Traffic and Transport Assessment

Block 9 and 11 – Section 8 Fyshwick ACT

Response to Comments Materials Facility & Freight Terminal Traffic and Transport Assessment

Figure 10 - Vehicles exiting the site

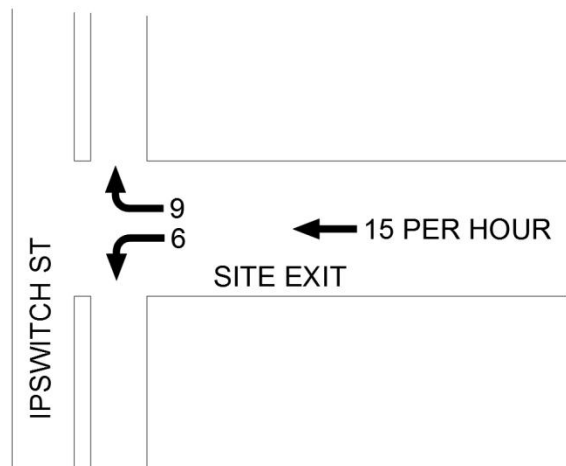
19. Figure 24 does not show the trucks leaving the site – extra truck movements (462)

Response: Exiting vehicles movement are shown in Figure 10, Section 2.6 of the traffic report

Figure 1 Crash severity plot (2012-2016)

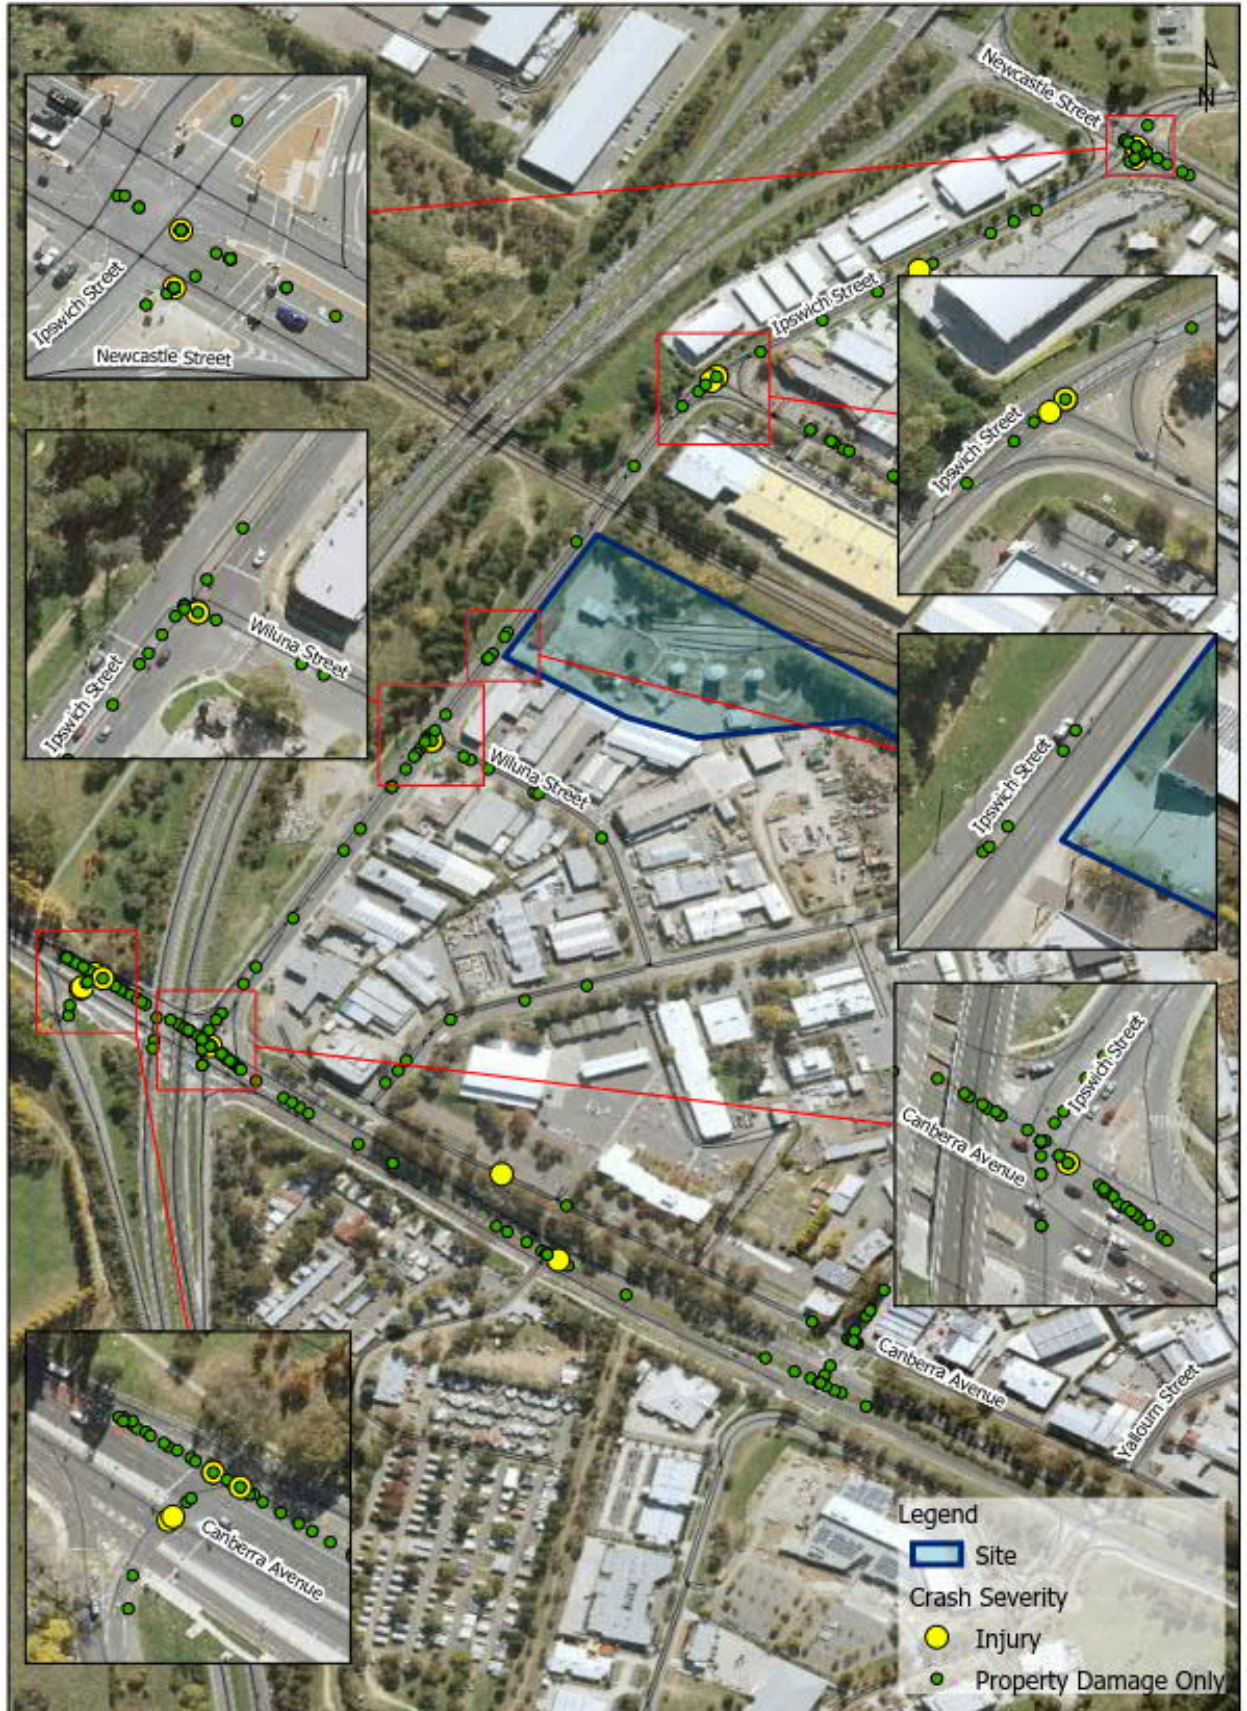
2. Accidents and safety (need a Road Safety Assessment) (070)

Response: a review of the crash history along the site frontage and broader area was considered and it was found that there was no significant crash history in proximity to the site. A plot of the nearby crashes showing the most recent five year period of recorded data from January 2012 to December 2016 is show in Figure 1. There were no fatality crashes recorded in the study area. In the broader area there were 16 injury crashes and 276 property damage only crashes recorded. Within the area, the most common crash type were rear end crashes, accounting for 62% of the crashes. Right-thru crashes at intersections were the second most common type of crash, accounting for 7% of all crashes in the study area.

In front of the proposed site access point, there were five recorded crashes over the 2012-2016 period. Four out of the five crashes were rear end crashes with the RUM (Road User Movement) codes listed in Table 1. The fifth crash a vehicle veered off the carriageway, striking an object. All crashes were property damage only crashes. Three of the rear end crashes occurred on wet surface where there was heavy or light rain. The crash where the vehicle veered off the carriageway occurred on a muddy or oily surface. These would indicate that adverse environmental conditions could be a contributing factor.

Figure 2 Weekday and Weekend Traffic Volume Profile

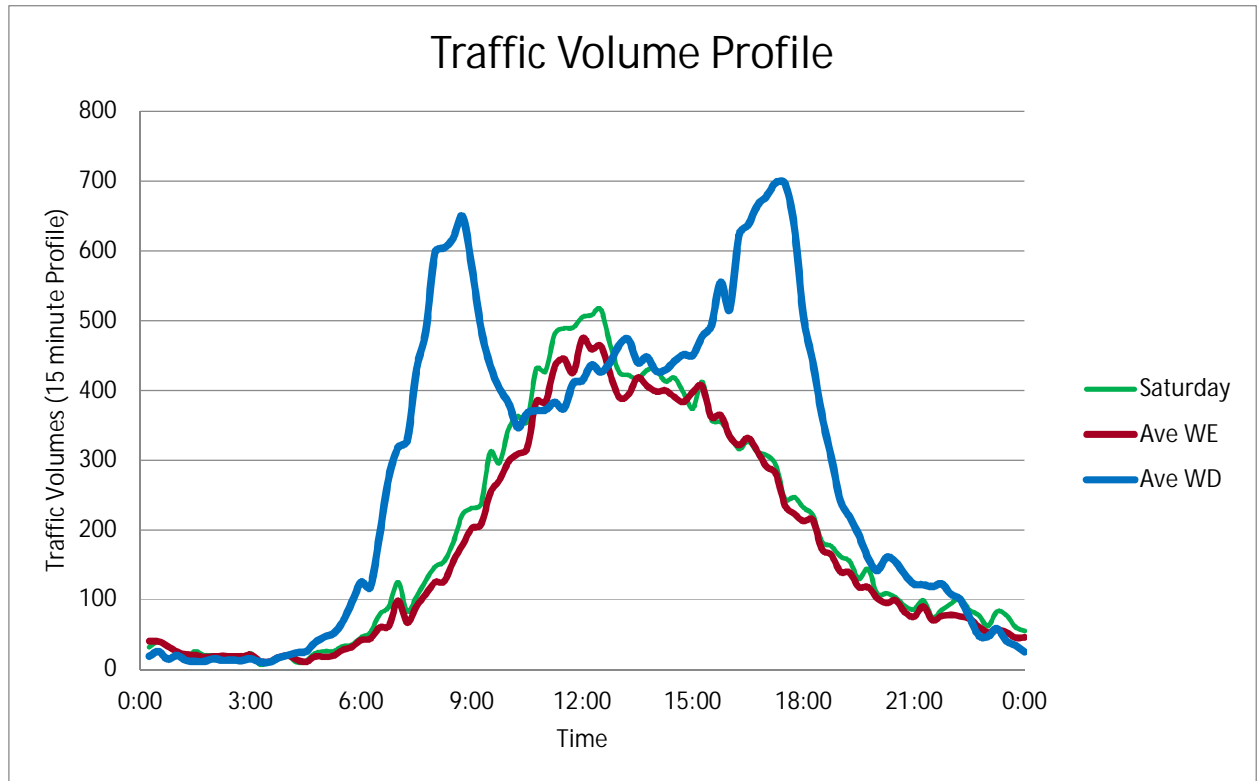
7. EIS has missed lunchtime peaks and Sat morning peak (030,121). Should assess worst case (7am-4pm) (030)

Response: The traffic volume profile for the area is shown in the figure below. This is based on SCATS intersection data. It compares the average weekday and weekend volumes as well as Saturday. The diagram shows the clear weekdays AM and PM network peaks.

Unlike commuter traffic where peak hours increase the demand to the development, heavy vehicles and waste collection drivers in general, avoid peak traffic times as they affect the operation and economics of operating a large vehicle. Traffic modelling and considerations used the highest volume weekday for heavy vehicle waste collection and over estimation of the expected vehicles by using the highest possible yield of vehicles waste diverted from Mugga Lane and other commercial waste. The traffic information used already represents the worst case. If the report focused on the peak periods only then we would have to report even lower heavy vehicles numbers.

Figure 4 Additional Hourly Truck Movements at each access

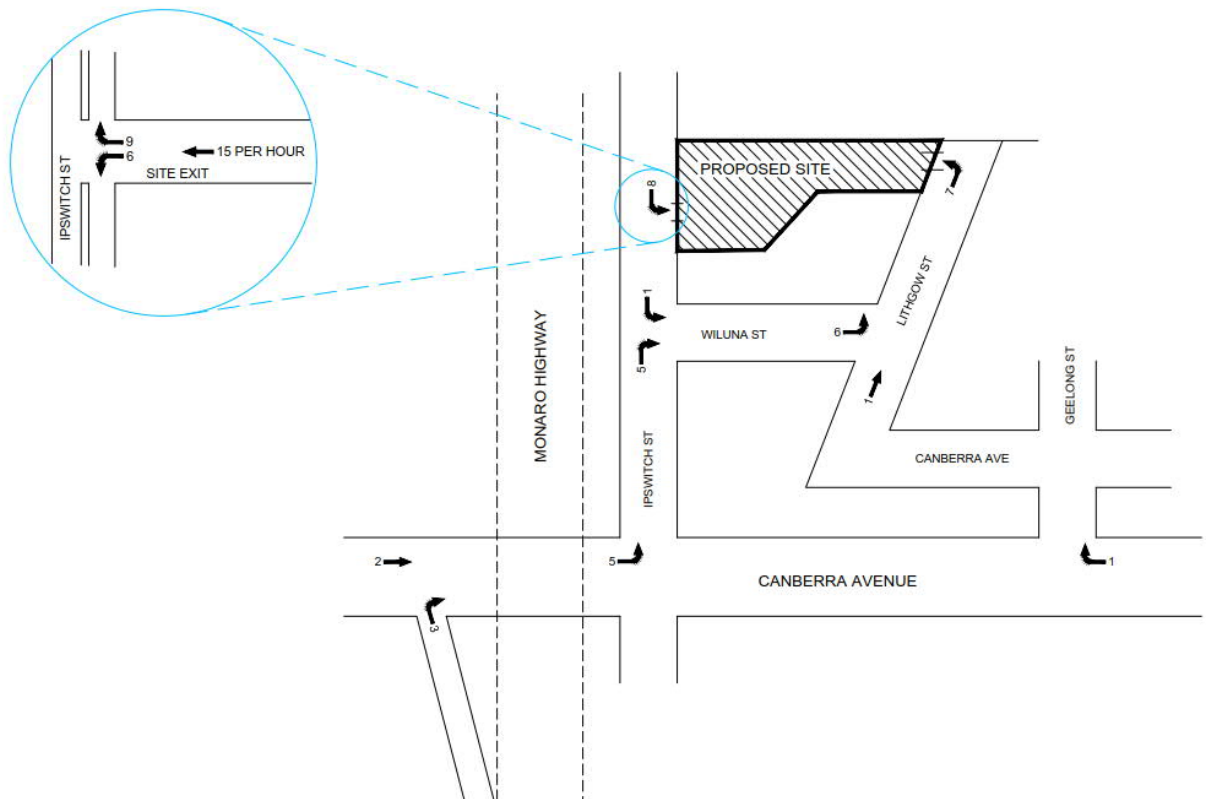
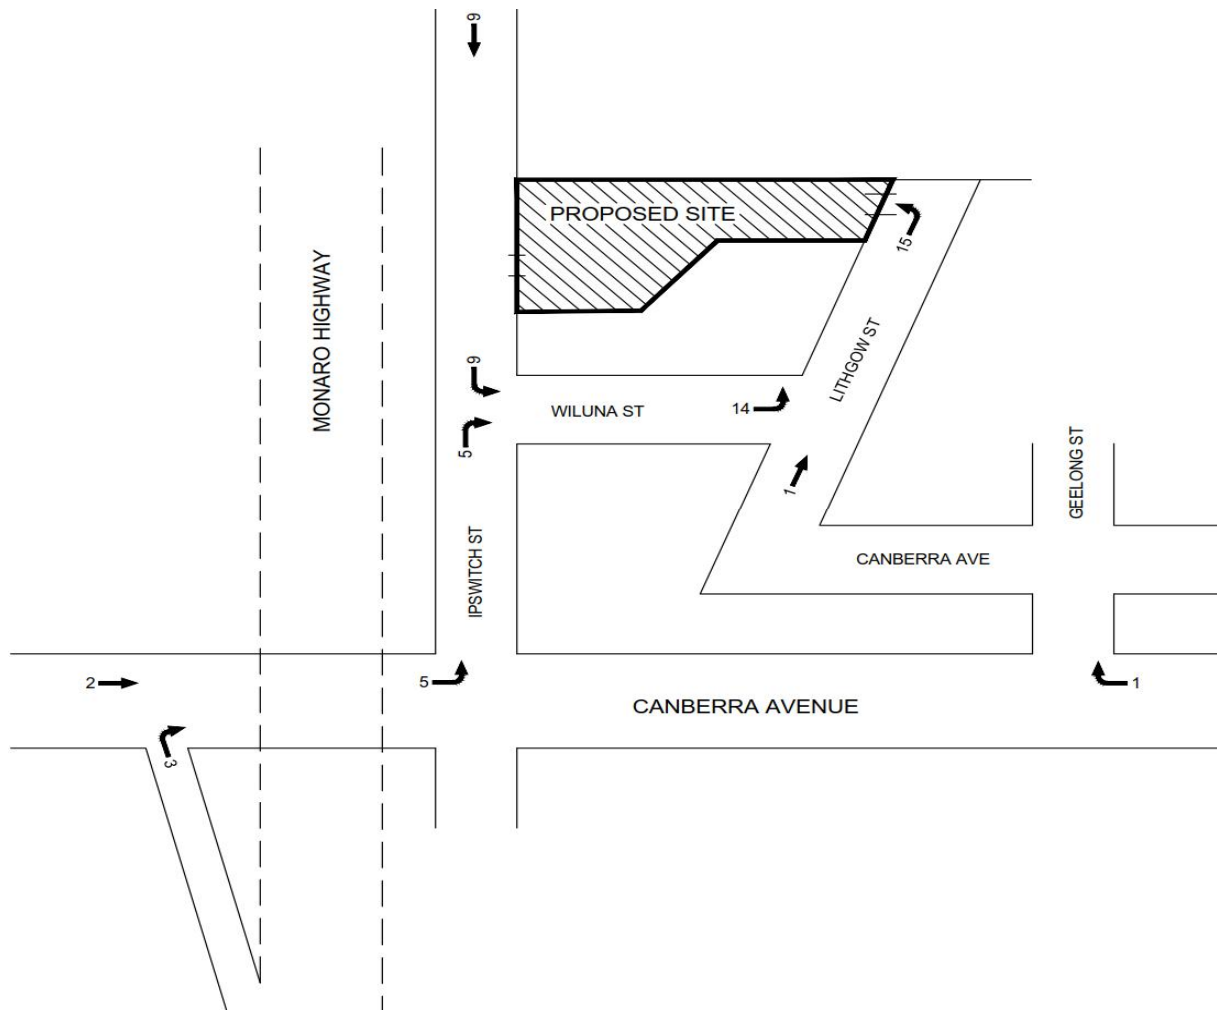
31. Under 2.3, the Canberra Strategic Transport Model concurs with Figure 5 and Figure 6 that the critical points, which are close to capacity, for future truck movements to reach the proposed development are:

Response: Figure 9 from the report outlines conservative heavy vehicle movements expected within an average hour. This does not include the likely reduction in heavy movements during the concertinaed network peak times likely. The demand from the Monaro Highway is only 3 additional truck movements and the right turn to Geelong Street is only one per hour. Figure 9 from the report has been updated and is presented above at Figure 4.
